200 Portage Avenue Townhome Project

Final Environmental Impact Report/
Responses to Comments on the Draft EIR

SCH#2021120444

May 2023

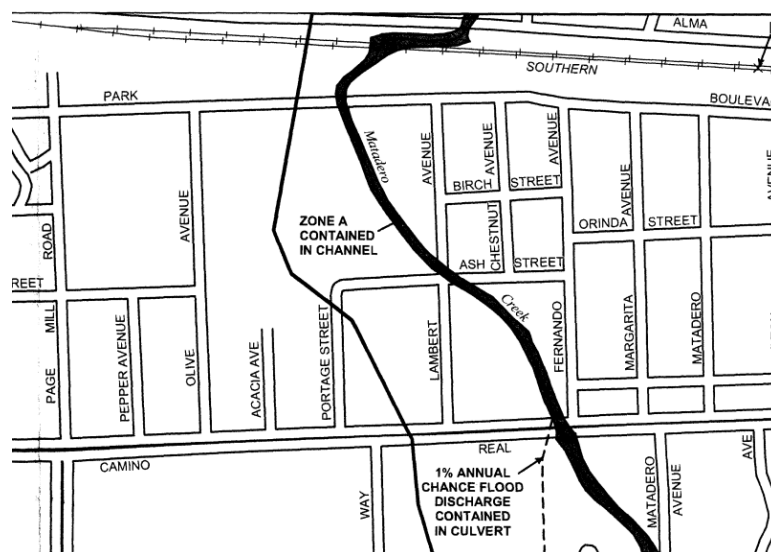
2. In the Hydrology and Water Quality section, the response to checklist question #4, which includes flood hazards, on page 4.9-15 needs to include a discussion of the flood hazards for the site. According to the Federal Emergency Management Agency’s (FEMA) current Flood Insurance Rate Map (FIRM) No. 06085C0017H, effective May 18, 2009, the majority of the site is within Zone X, areas of 0.2% annual chance flood; areas of 1% annual chance flood with average depths of less than 1 foot or with drainage areas less than 1 square mile; and areas protected by levees from 1% annual chance flood. However, the map also shows a Special Flood Hazard Area (SFHA) Zone A, without base flood elevations, along Matadero Creek and adjacent to the creek. The map notes the 1% flood annual chance flood discharge is contained in the creek, though the mapping does not show it aligned with the creek throughout the site. It may be necessary to have the map revised to accurately show the Zone A in order to be in compliance with the City’s floodplain ordinance since it appears that some of the homes would be within the mapped SFHA Zone A area unless the map is corrected. 2

The commenter states that the Hydrology and Water Quality Section of the Draft EIR should include a discussion of flood hazards for the site. The commenter states that according to the Federal Emergency Management Agency's (FEMA) current Flood Insurance Rate Map (FIRM), the majority of the site is within Zone X; however, a Special Flood Hazard Area Zone A is located along Matadero Creek. The commenter states that the flood zone does not align with the creek and that the map may need to be revised to accurately show Zone A or it would appear that some of the proposed residences are within flood Zone A.

On October 26, 2006, FEMA issued a Letter of Map Revision (LOMR) for the FIRM for the project area. According to the LOMR, Zone A is contained within the Matadero Creek channel. Therefore, proposed residences would not be located in Flood Zone A. An image of the revised FIRM is shown below for reference.

Proposed Project Landscape Plan Sheets

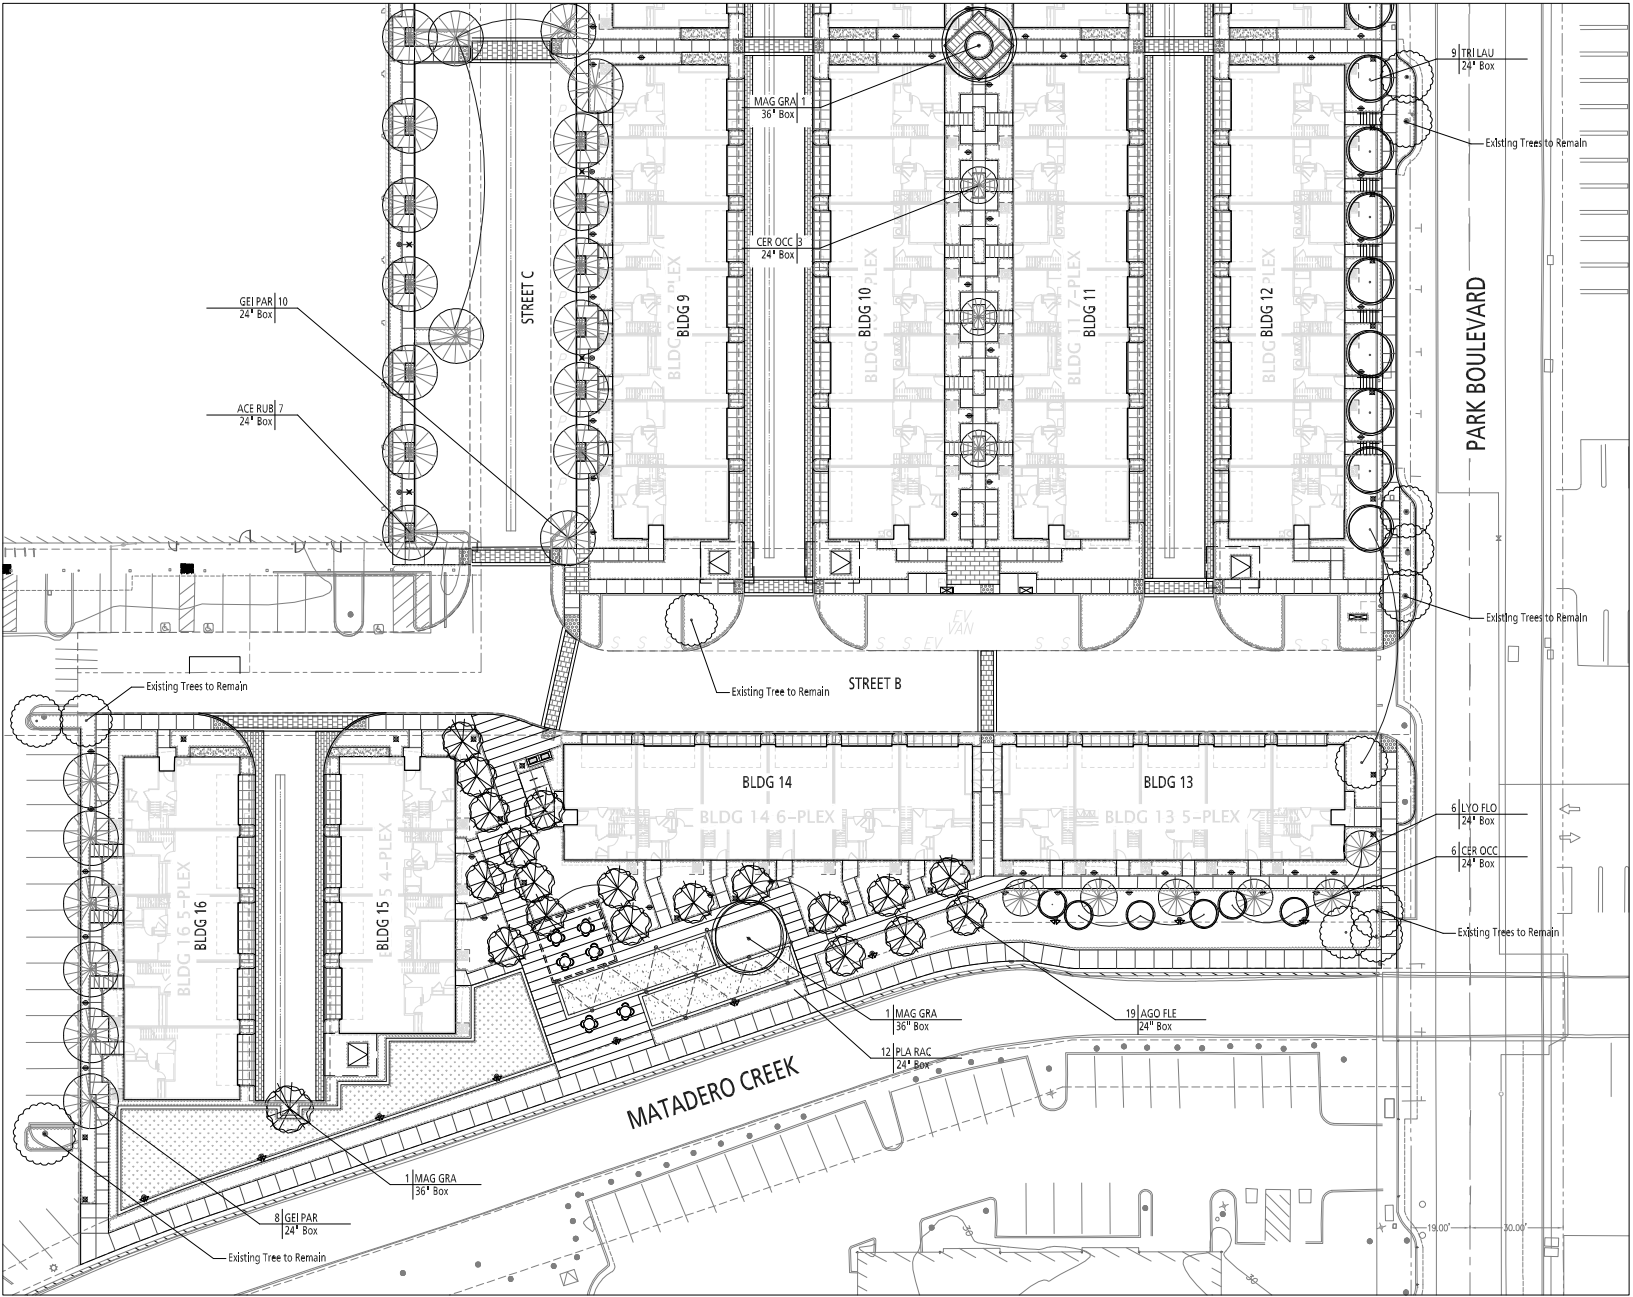
- 1) 2.5.5 Trees -- why is a need to remove so many mature trees on the property for development? There should be effort made to remove less trees, especially mature ones that have been growing for maybe tens or hundreds of years. The proposed replacement trees are not identified, nor are they listed where they would be placed. Why is there no information on either the type of replacement trees nor the potential growing period of these trees or how quickly they could replace the existing mature trees. Why isn't there any involvement by the public in deciding why these trees should be kept or destroyed? 1

Referring to Section 2.5.5, of the Draft EIR, the commenter asks why there is a need to remove trees on the project site and asks about the type and location of replacement trees. The commenter suggests that there should be more effort to preserve trees and the public should be involved in the decision.

Since publication of the Draft EIR, revisions have been made to the proposed project's landscaping plan. As a result, revisions to Section 2, *Project Description*, and Section 4.9, *Effects Found Not to be Significant*, of the Draft EIR were made. These revisions are included in Chapter 4, Revisions to the Draft EIR, of this document. There are currently 100 trees within or adjacent to the area of development. The proposed project would preserve 17 trees on the site and 2 trees off-site, while removing 83 trees. Of the trees to be removed, four redwoods and two Coast live oak are considered "protected trees" under the City's Tree Protection Ordinance. The project would involve planting 165 proposed new trees around the site for a net increase of 82 trees. The revised landscape plan is included in Attachment A of this document. Although the project would result in removal of three additional "protected trees" compared to what was analyzed in the Draft EIR, the City's Tree Preservation and Management Ordinance requires compliance with the Tree Technical Manual, which outlines the requirements for removal and replacement of protected trees consistent with the tree canopy requirements. A Tree Removal Permit would be required prior to removal of the street tree and would further ensure that the requirements of the Ordinance are met. Compliance with the City's regulations would ensure that impacts to street trees remain less than significant, the same conclusion as in the Draft EIR.

An analysis of the proposed project's consistency with the updated ordinance, which does not apply to this project, is not warranted. Additional details about the landscaping plan for the proposed project can be found in Attachment A of this document.

Single-Story Adaptive Reuse Diagram

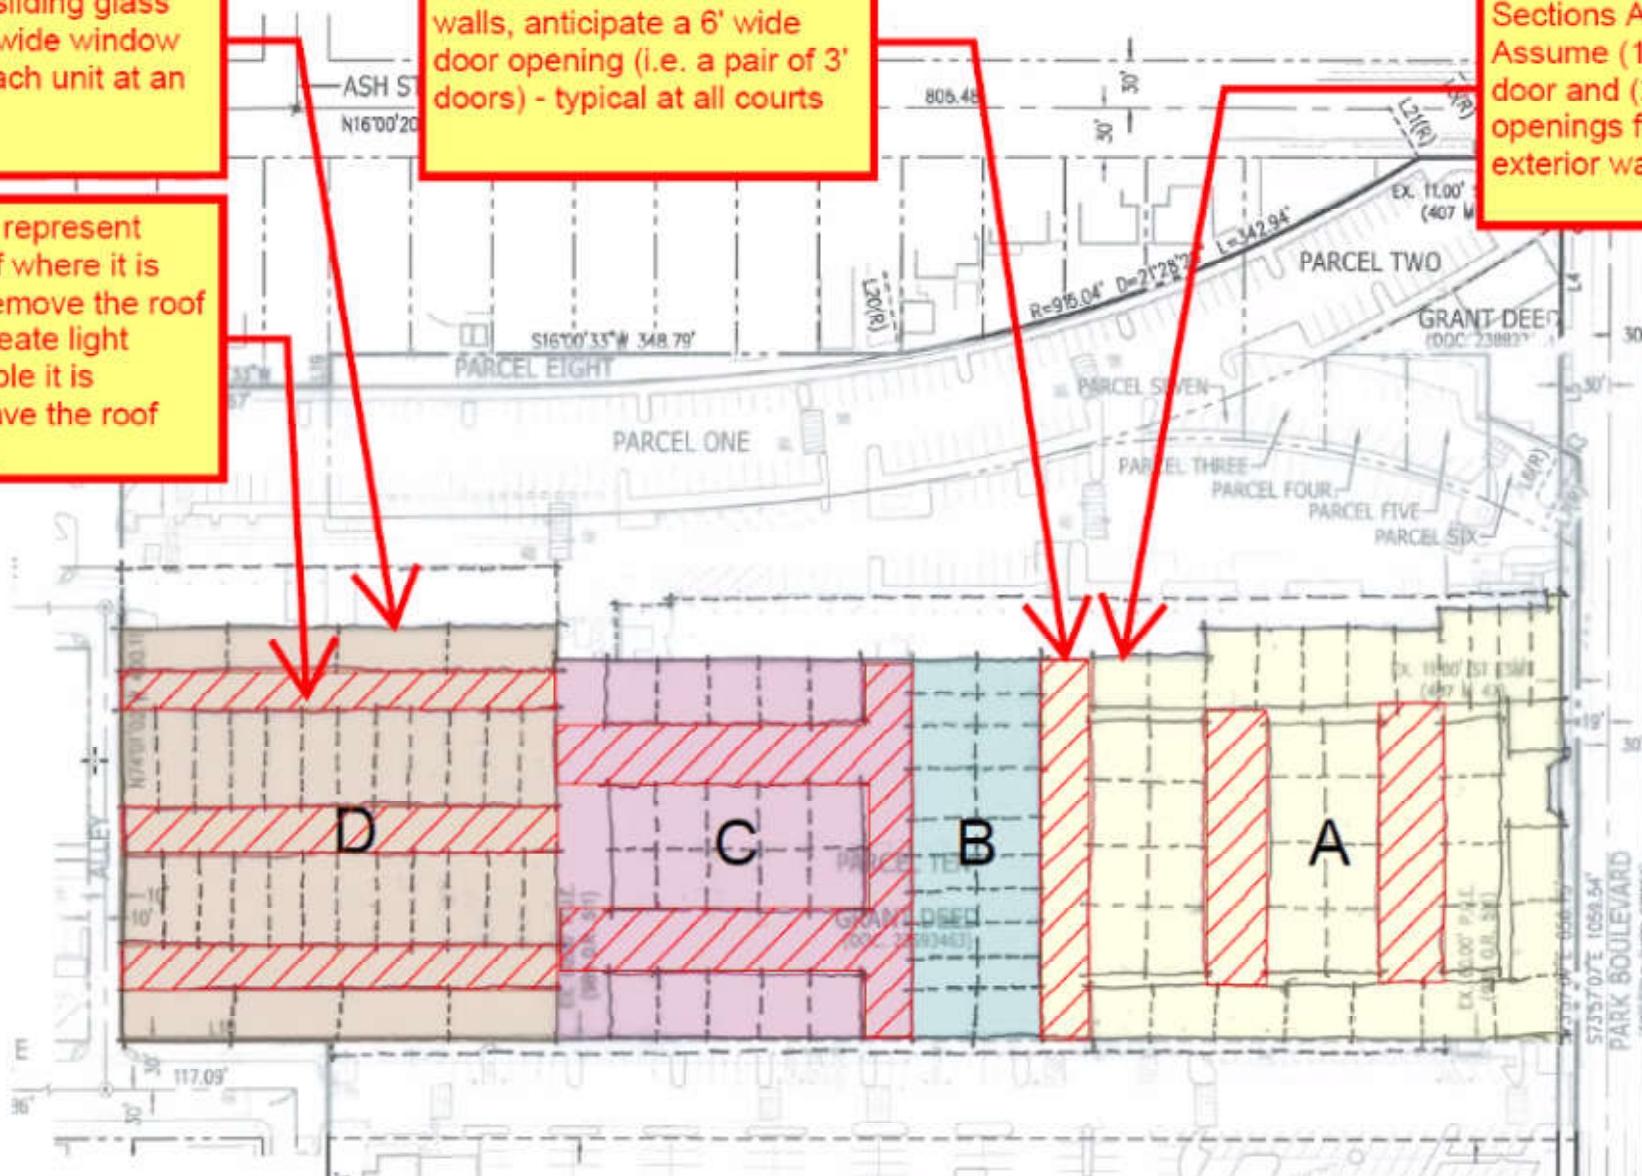
The Draft EIR includes an analysis of an Alternative 2, Adaptive Reuse of Eligible Historic Resource for Housing. For Alternative 2 to feasibly attain most of the basic project objectives, and because the City Council's preferred alternative for the North Ventura Coordinated Area Plan assumed a height of approximately 35 feet and 293 housing units across the project site, the City selected a three-story adaptive reuse scenario for detailed analysis.

Following receipt of this comment and similar comments, the City requested that the applicant prepare the diagram in Attachment B showing a conceptual site plan for a single-story adaptive reuse. The diagram exemplifies how even a single-story alternative would not eliminate the significant historic resources impact, due to the significant revisions would be necessary to meet life safety requirements and provide viable residential units. Any reuse of the structure for residential units, regardless of how many stories tall the structure would be, would require that all four walls of the building exterior be modified through the introduction of window and door openings to accommodate conversion to residential use and meet residential ingress/egress building code requirements. The large open interior of the building would also have to be modified by adding light wells to provide access to light and air for all units and demised to create individual units, where the Secretary of the Interior's standards would discourage subdividing the building into smaller spaces. Further, to accommodate residential uses, substantial structural upgrades would be required. Additional kitchens and bathrooms would be required for residential use, such that plumbing and electrical systems would need major upgrades to supply electricity and water. Other major upgrades would be needed for ventilation and insulation and to meet current green building and ADA requirements. It should also be noted that the building, though recommended eligible, is not currently listed in the CRHR and is therefore not eligible for historic exemptions under the California Historic Building Code. Because of the extent of work required to convert the building to residential uses and comply with building code requirements, even if the site were to be listed in the CRHR and therefore could be eligible for certain exemptions for required upgrades, adaptation of the building
